Subject: Response to Request for Additional Information - ERM Independent Hazard Analysis for
Edge Cable Holdings

Attachment: Figure 1, Jupiter Plan View and HDD Profile

RESPONSE TO REQUEST FOR ADDITIONAL INFORMATION - ERM INDEPENDENT HAZARD ANALYSIS FOR EDGE CABLE HOLDINGS

FIGURE 1 Jupiter Plan View and HDD Profile

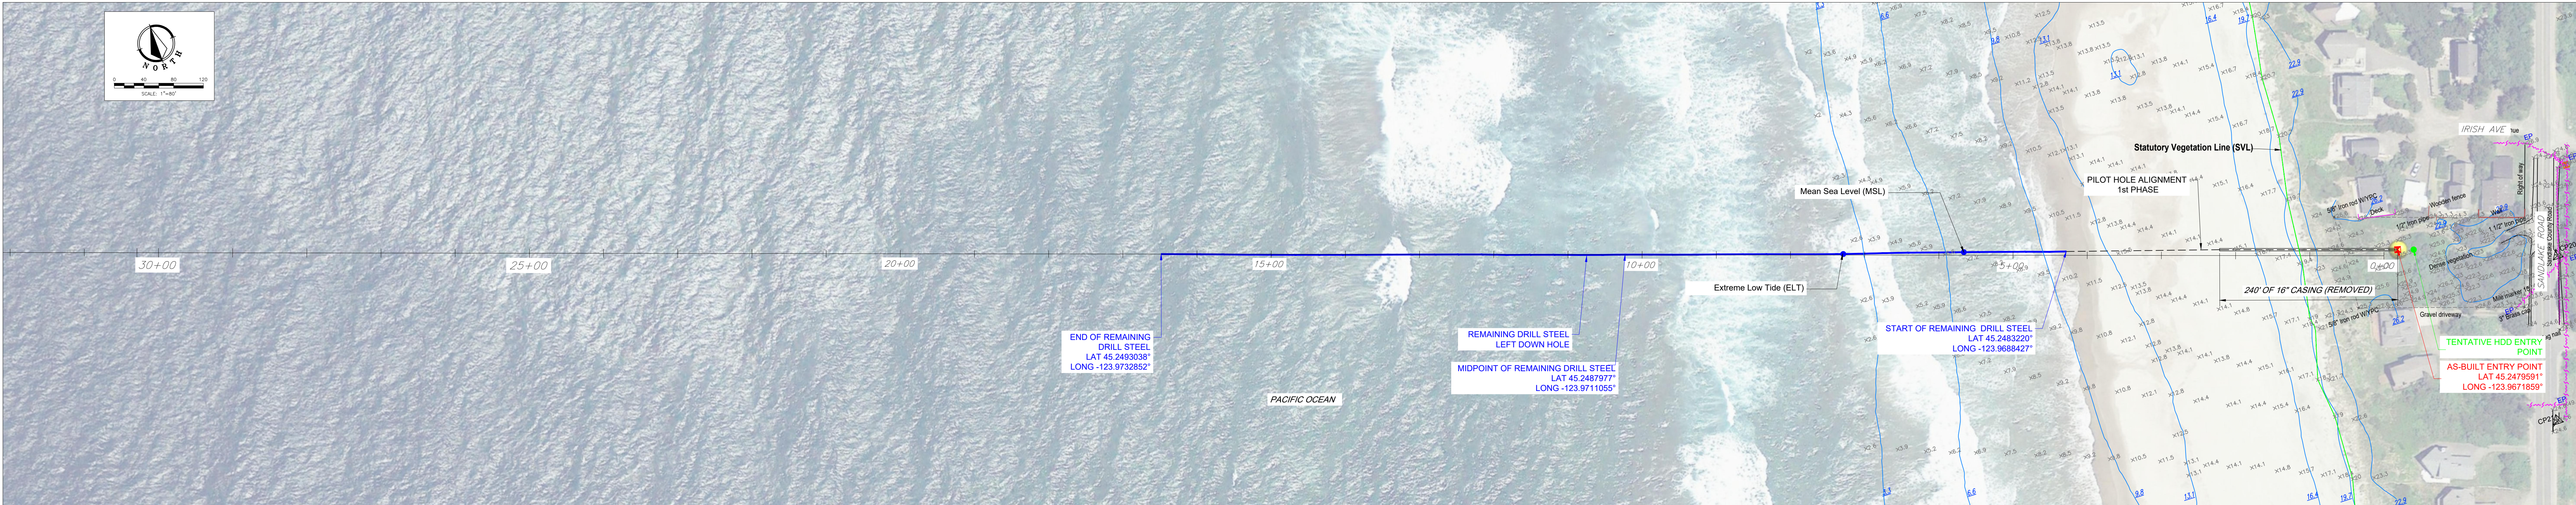
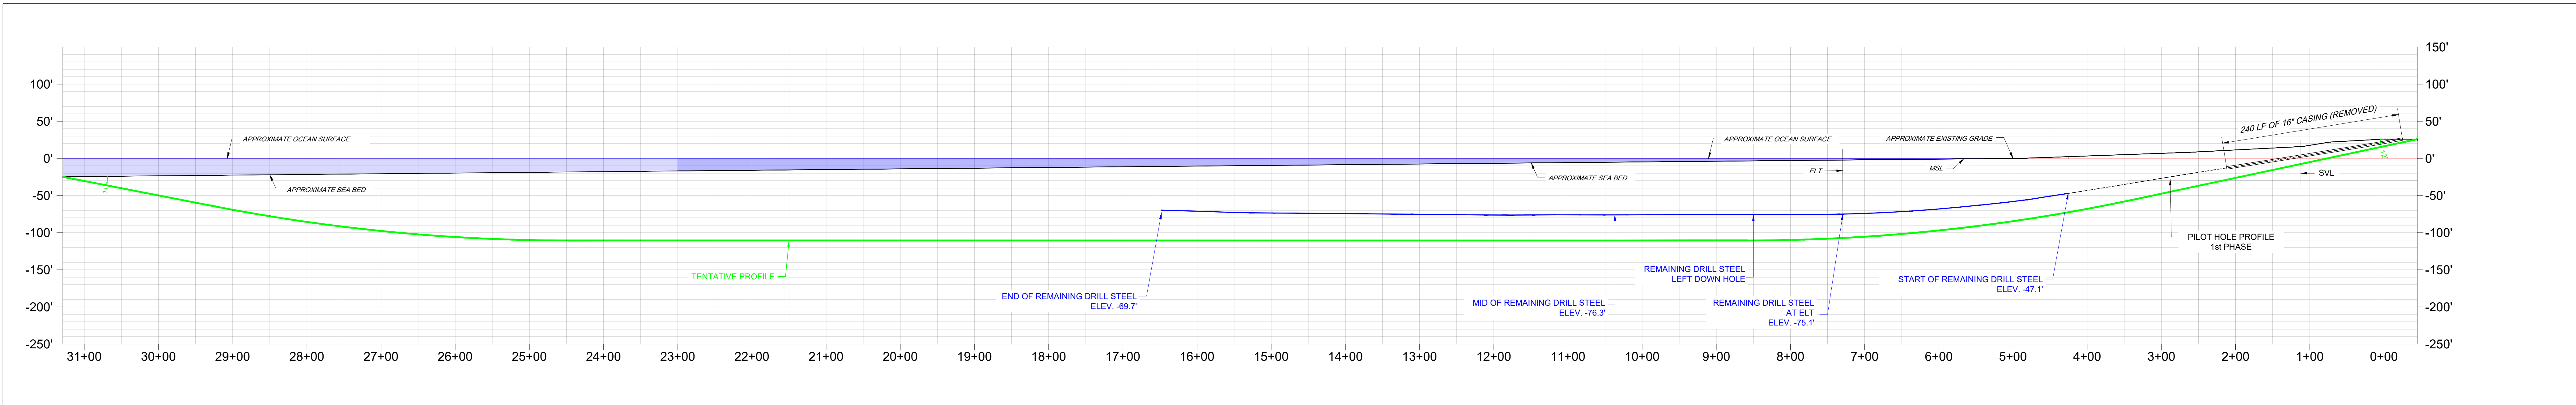
3. **The ERM analysis does not clearly specify the location of the Remaining Materials in relation to the “ocean shore” boundaries identified above.**

There are several references to the remaining materials being left “*at an average depth of approximately 50 feet below the seafloor between approximately 1,690 and 520 feet offshore.*” If all of the Remaining Materials are located entirely seaward of the extreme low tide of the Pacific Ocean, then it will be important to indicate so. If some of the Remaining Materials were left landward of extreme low tide under the ocean shore, then it is necessary to identify what portion of the ocean shore contains Remaining Materials, and what those materials are (steel bore casing, drilling mud, drill pipe, or other).

4. **In addition, the depth of the borehole and any Remaining Materials nearest the bore entry hole are necessarily at a shallower depth than those under the seafloor, so it is important to identify their depth under the ocean shore instead of identifying the “average depth of 50 feet.” In order to clarify the location and depth of the borehole path across the ocean shore and the location of the Remaining Materials, please direct ERM to provide a cross section, drawn to scale, which visually illustrates these features in relation to both the ocean shore and the seafloor. For example, the analysis suggests all remaining materials are located seaward of 7.5 feet past Joint #15. This location should be identified in your cross section.**

8. **Section 3.1.1.1 focuses on potential eco toxicity levels on the benthic zone and water column. As mentioned above, the borehole under the ocean shore, particularly nearest the bore entry point is shallower than the “average” depth of 50 feet. It is essential that additional analysis focus on potential toxicity levels if any remaining drilling fluid emerged to the surface of the ocean shore for any reason. As mentioned above, if no remaining drilling fluid is located under the ocean shore, then the analysis should indicate so, and also distinguish the potential of any release within OPRD’s ocean shore jurisdiction.**

- 10. One last matter of concern is that of any risks associated with attempts to drill a new borehole in close proximity to, and along the same path as the failed borehole, considering the lithology surrounding the borehole has likely collapsed since the drill pipe and steel bore casing was removed, as stated in Section 2.2.1.**

Please see description above in Response #1 and Figure 1 attached for a clear specification of Remaining Materials within the ocean shore boundaries.

As requested, the locations and depths of Remaining Materials and the borehole path beneath the ocean shore are depicted on Figure 1, which includes a plan and cross sectional view drawn to scale. As shown on Figure 1, the Remaining Materials extend approximately 300 feet into OPRD’s jurisdiction (the “ocean shore”) from the Extreme Low Tide line, ranging in depth from -47.1 to -75.1 feet [NAVD88]. The demarcation of the ocean shore boundaries, specifically the Extreme Low Tide (based on Lowest Astronomical Tide) and Statutory Vegetation Line (SVL) are shown on the figure to visually illustrate the Remaining Materials in relation to these boundaries.

The locations and depths of Remaining Materials and the borehole path beneath the ocean shore are depicted on Figure 1.

The “new borehole” (“2021 borehole”) design will be confirmed upon completion of additional geotechnical surveys. The 2021 borehole (shown as the green line labelled “Tentative Profile” on Figure 1), in proximity to the previous borehole (“2020 borehole”), does not present risk for significant displacement of the 2020 bore pipe or liquefaction of drilling mud nor does it affect the stability of the subsurface where the 2021 borehole will advance. While the drilling contractor has indicated that they will make every effort to avoid contact with the Remaining Materials, as described below, the risks associated with direct contact are negligible.
